W3F1-2017-0067

Subject: License Amendment Request to Remove Technical Specification 3/4.3.2  
Table 4.3-2 Note 3 Exemption for Testing Relays K114, K305, and K313  
Waterford Steam Electric Station, Unit 3 (Waterford 3)  
Docket No. 50-382  
License No. NPF-38

**Analysis of Proposed Technical Specification Change**

**Revised (Markup) Technical Specification Page**

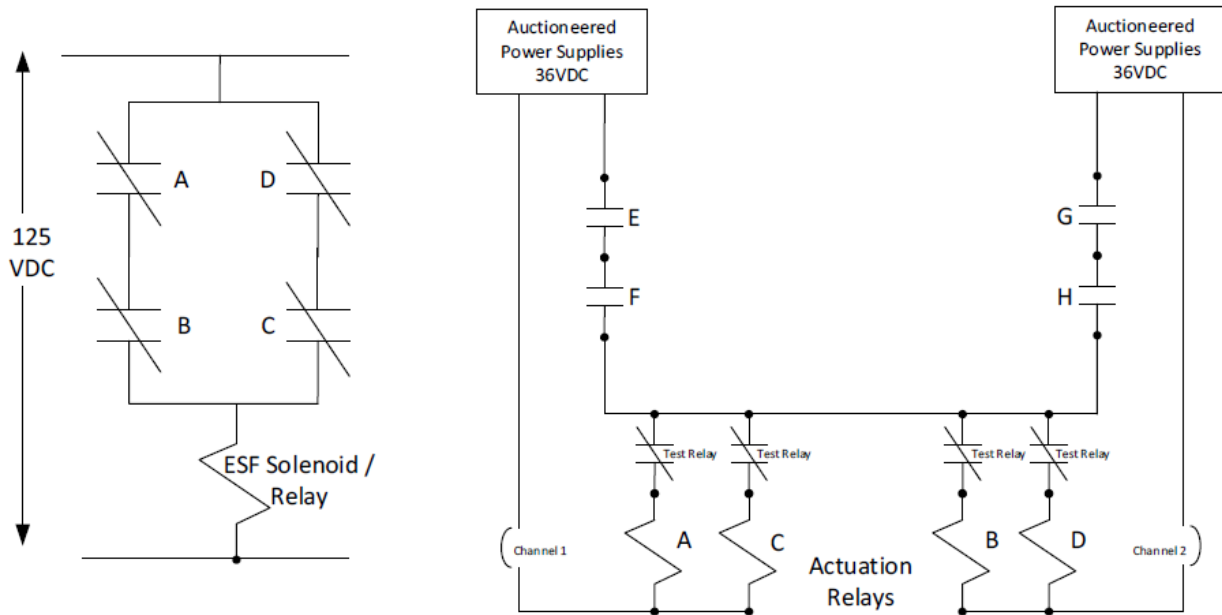
The following figure shows the simplified current configuration of the ESFAS single point vulnerability. This is a generic arrangement for explanation purposes. The specific relay changes will be shown in the next sections.

The ESFAS single point vulnerability is associated with the power supply arrangement. If a short circuit were to occur across the relay A coil, power would be lost to the left half of the ESF bus resulting in the de-energization of relays A and C. Such failures would not affect relays B and D as these have a separate negative and circuit breaker. Under this scenario, the ESF equipment associated with relay A would actuate. This is the single point vulnerability identified for MSIS relays K305 and K313, and for CSAS relay K114.

#### 4.2 Main Steam Isolation Signal Single Point Vulnerability Modification

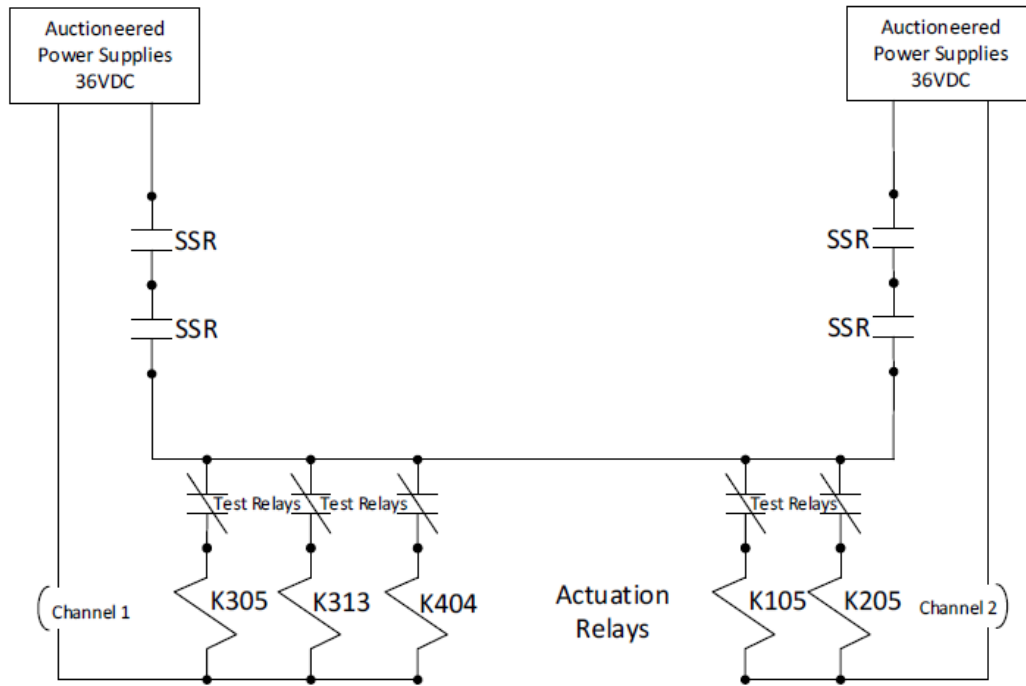
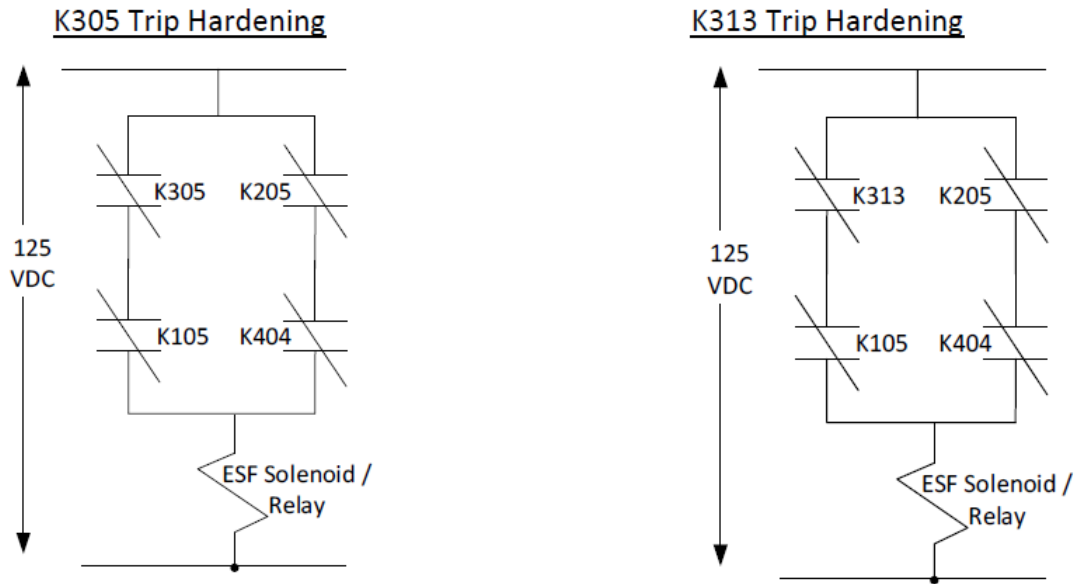
The K305 relays will be trip hardened by adding 3 additional relays creating a 2 out of 2 paralleled with 2 out of 2 logic scheme. Spare relays used to trip harden the K305 relay are K105, K205, and K404. K305 and K404 are powered from one power supply while K105 and K205 are powered by a separate power supply. K305 trip hardened contacts are wired in series with K105 contacts. K205 contacts are wired in series with K404 contacts. K305 AND K105 OR K205 AND K404 are required to close to actuate associated downstream ESF equipment.

The K313 relays will be trip hardened by adding 3 additional relays creating a 2 out of 2 paralleled with 2 out of 2 logic scheme. Spare relays used to trip harden the K313 relay are K105, K205, and K404. K313 and K404 are powered from one power supply while K105 and K205 are powered by a separate power supply. K313 trip hardened contacts are wired in series with K105 contacts. K205 contacts are wired in series with K404 contacts. K313 AND K105 OR K205 AND K404 are required to close to actuate associated downstream ESF equipment.

#### 4.3 Containment Spray Actuation Signal Single Point Vulnerability Modification

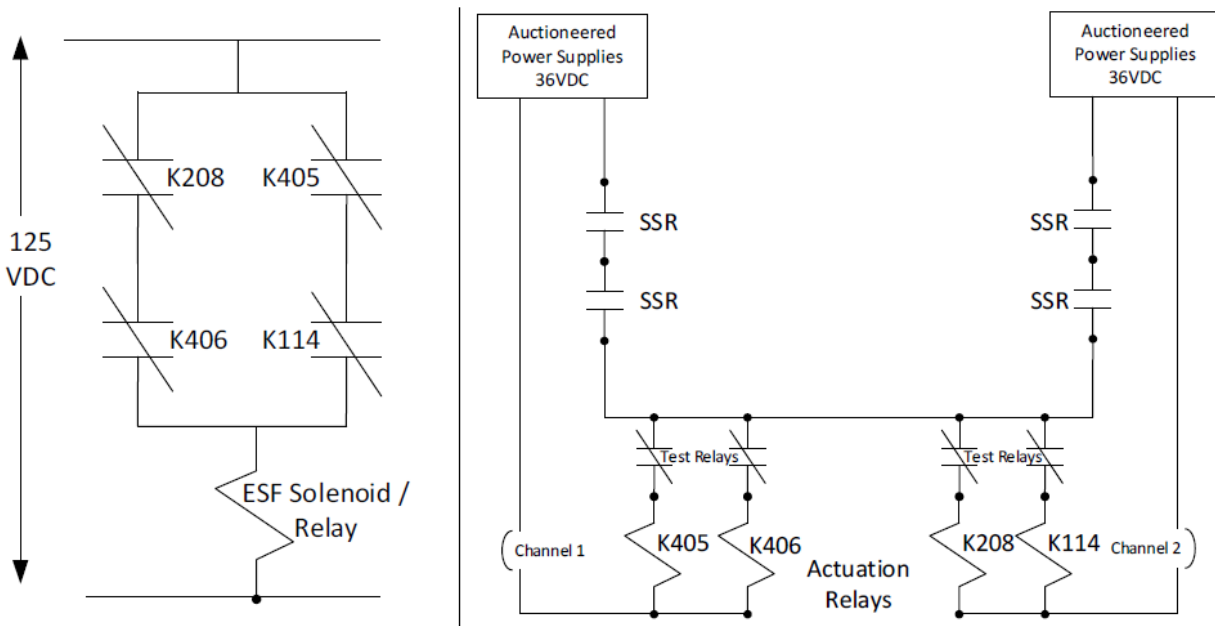
The K114 relay will be trip hardened by adding 3 additional relays creating a 2 out of 2 paralleled with 2 out of 2 logic scheme. Spare relays used to trip harden the K114 relay are K208, K405, and K406. K114 and K208 are powered from one power supply while K405 and K406 are powered by a separate power supply. K114 trip hardened contacts are wired in series with K405 contacts. K208 contacts are wired in series with K406 contacts. K114 AND K405 OR K208 AND K406 are required to close to actuate associated downstream ESF equipment.

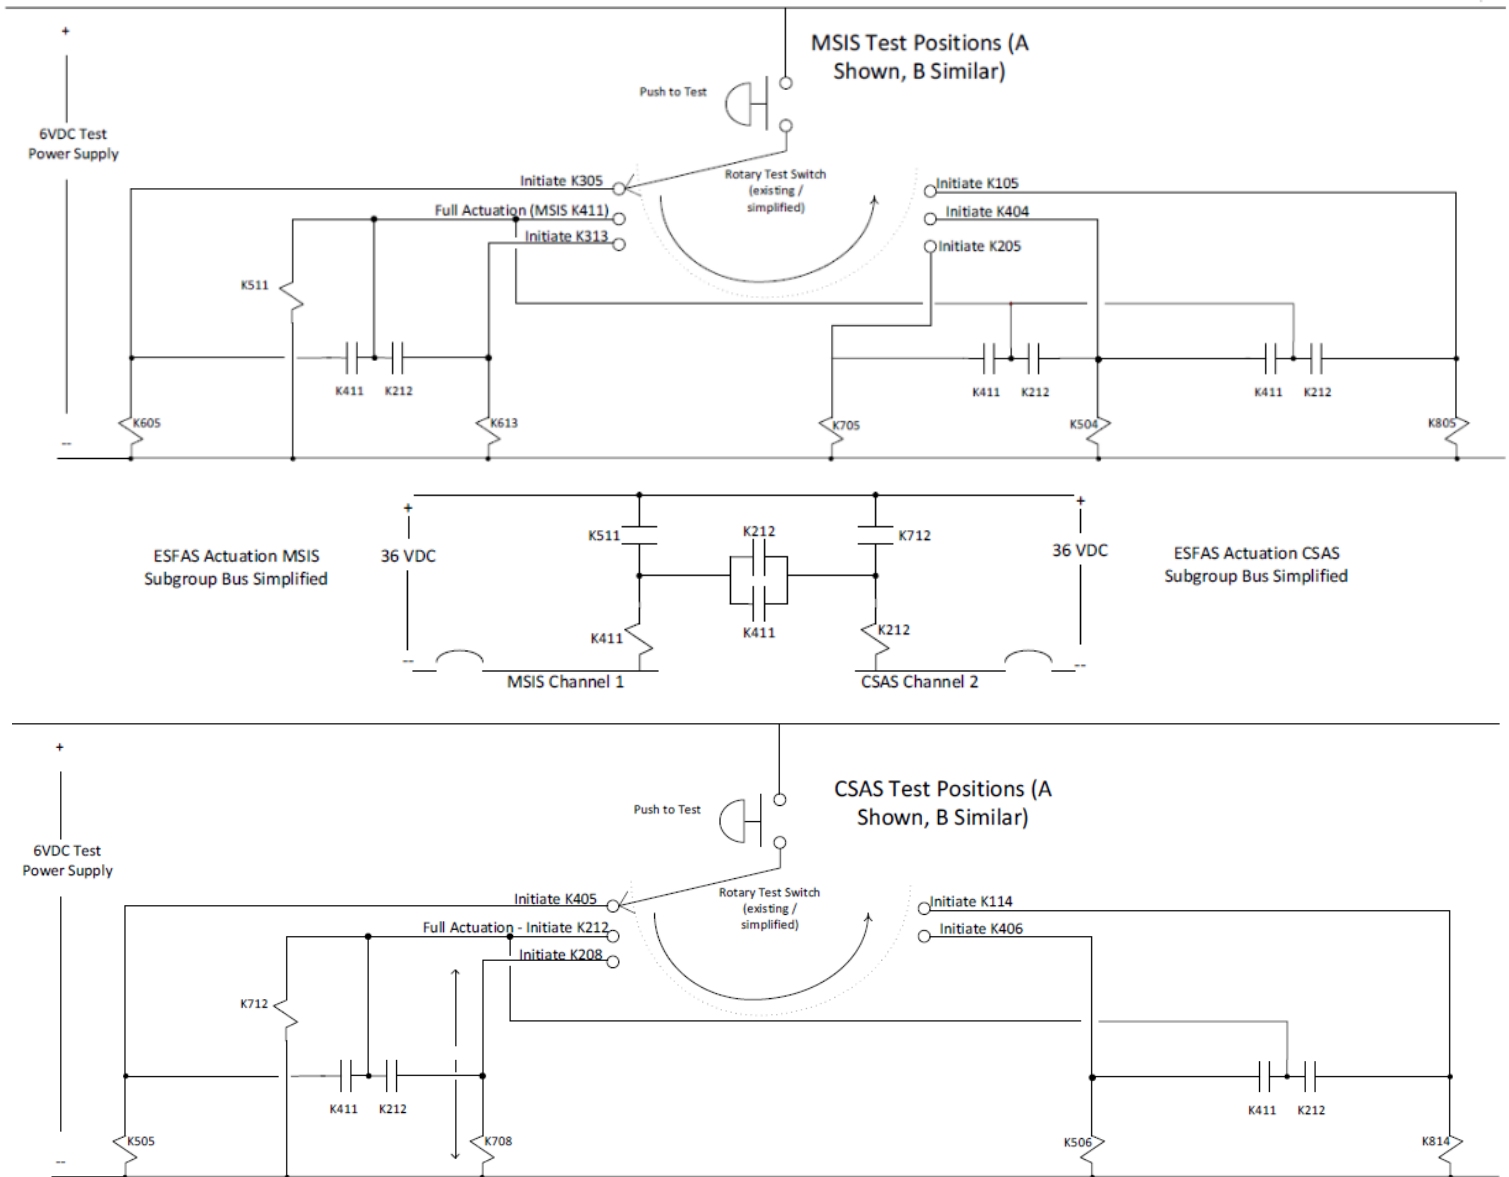
Spare relays used in the trip hardening scheme have associated test relays located in the ESFAS cabinets that are pre-wired to test switches in the Control Room. This wiring exists currently for the spare actuation relays. This change will take advantage of the pre-wired test relays and switch positions to incorporate both discrete online testing and gang operated offline testing that will test both actuation relays and downstream ESF devices. The next figure is a simplified version of the test switch arrangement and how it discretely controls the actuation relays. This figure represents any given ESFAS actuation relay (A, B, C, D) and its test relay pair (a, b, c, d). By aligning the rotary switch to the “c” position and pressing the test pushbutton, “c” test relay would be energized by the 6 volt source and its associated normally closed contact in series with ESFAS actuation relay “C” would be de-energized from its 36 vdc source. The testing of actuation relay “C” is achieved without dropping out the entire actuation relay bus. This same method is employed for each actuation relay. By trip hardening the relays with 3 other relays, a single relay no longer actuates the downstream ESF function and can be tested at power. This design change assigns existing spare switch positions in the control room to allow testing of each trip hardened relay.

The gang operation of MSIS and CSAS utilize two relays (K212 and K411) (formerly spare actuation relays) and associated test relays K511 and K712. The spare actuation relay contacts will be used to tie test actuation power to the test relays of trip hardened relays allowing for simultaneous dropout of trip hardened relays for MSIS or CSAS. The gang operation is achieved using two existing spare relays and associated test relays including their pre-wired and pre-assigned test positions in the control room. Two relays are used to prevent introduction of a single point vulnerability if only one relay were used. The K212 and K411 relays provide the contacts and wiring to provide 6 VDC test power to all associated test relays for trip hardened contacts of MSIS and CSAS. The MSIS and CSAS test relay coil power is selected using the control room test switches and pushbutton. Only MSIS or CSAS can receive the test power at any given time due to exclusivity of the test switch. When aligned to K411, only test relays associated with MSIS will receive the 6 VDC necessary to pickup up test relays K605, K613, K705, K504, and K805. Power is provided through the test switch alignment and depressing the 'Push to Test' pushbutton. Once the pushbutton is depressed, the 6 VDC source picks up test relay K511. Test relay K511 contact closes providing 36 VDC power to MSIS subgroup relay K411. K411 contacts close to provide the same 36 VDC source to K212. Contacts for K411 and K212 provide 6 VDC power source ties from the test switch to all test relays associated with MSIS. The contacts which tie the coils of actuation relays K411 and K212 together are utilized to maintain electrical separation when not in gang operation. The relays K411 and K212 are shared between MSIS and CSAS; the 6 VDC power source is exclusive such that only power is available to MSIS or CSAS when aligned. The next figures are simplified versions of the test switch arrangement and the gang operation of the MSIS and CSAS.

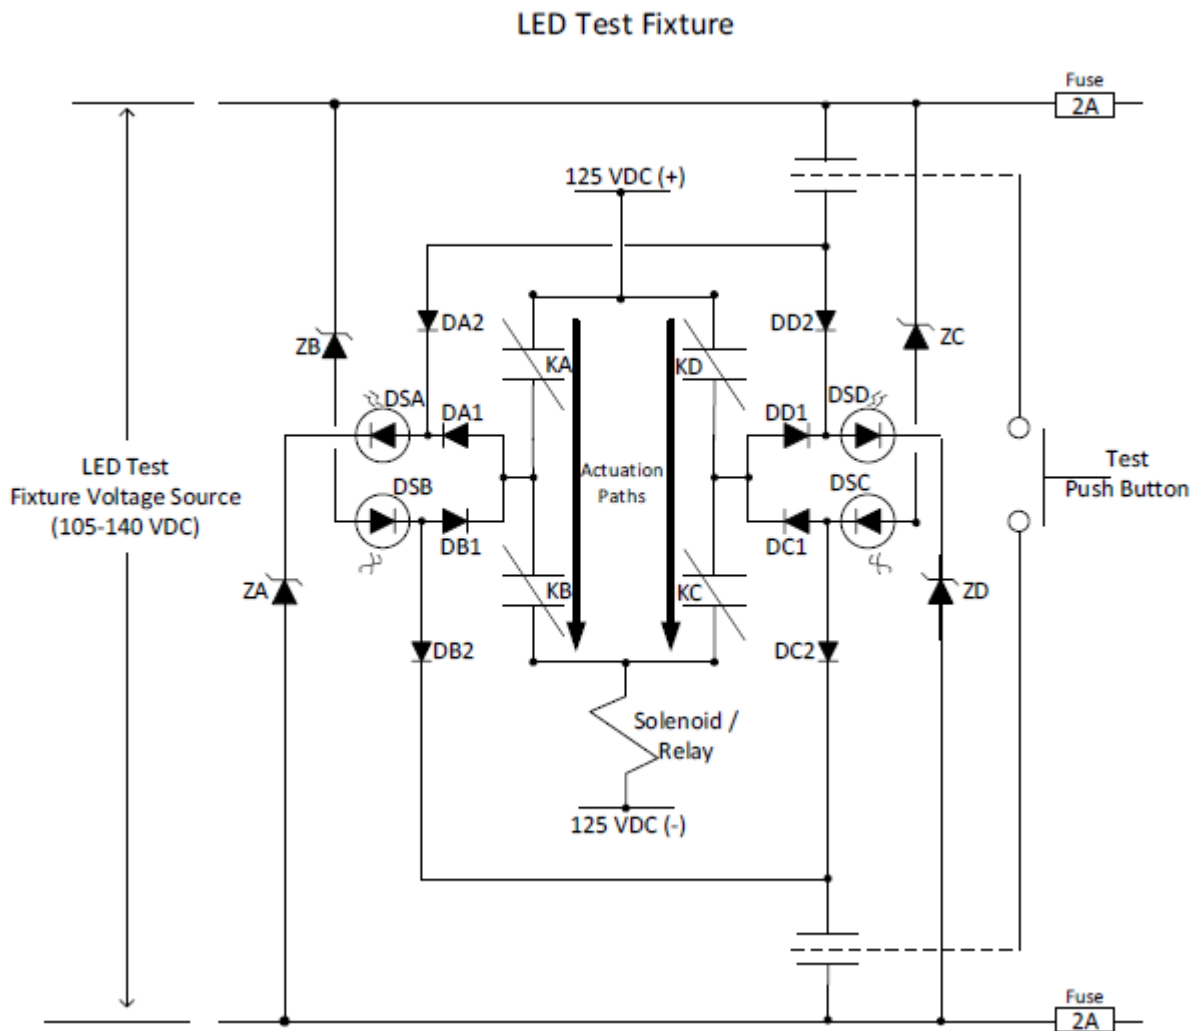
The LED Test Fixture provides light indications of trip hardened contact closures during testing. The LED Test Fixture is also used during normal operating rounds to verify trip hardened relays have not failed during the operating cycle. A test pushbutton is provided for lamp checks during operator rounds to verify all LEDs are in working order.

During a full actuation of either CSAS or MSIS, either by gang operation during offline testing or by actual ESFAS signal received due to an event, the LED Test Fixture is not used. This is acceptable as full actuations are verified by proper operation of the downstream ESF component indications (valve closes, pump starts, etc.). Existing indications in the control room will continue to be relied upon for ESF component response during MSIS and CSAS full actuations with no changes required.

The next figure is a simplified diagram of the LED Test Fixture. KA through KD are the subgroup actuation relay contacts. DSA through DSD are the LEDs used to monitor their respective actuation contact. The following examples assume all contacts are open unless stated otherwise. As an example, assume Operations is performing an online surveillance test of each relay (KA, KB, KC, KD) discretely, meaning only one is being tested at a time. The first step Operations will perform is verifying the LEDs are working properly by depressing the 'Test Push Button.' Once all LEDs are verified illuminated, the pushbutton will be released, extinguishing the LEDs. Next, Operations will verify no LEDs remain illuminated (which would indicate a failed actuation relay or contact). Once all LEDs are verified extinguished, testing may be performed. Assume KA is under test. Contact KA is monitored by LED DSA. When KA is closed, DSA is illuminated (ON). When KA is open, DSA is not illuminated (OFF). The remaining LEDs (DSB through DSD) function in the same manner.
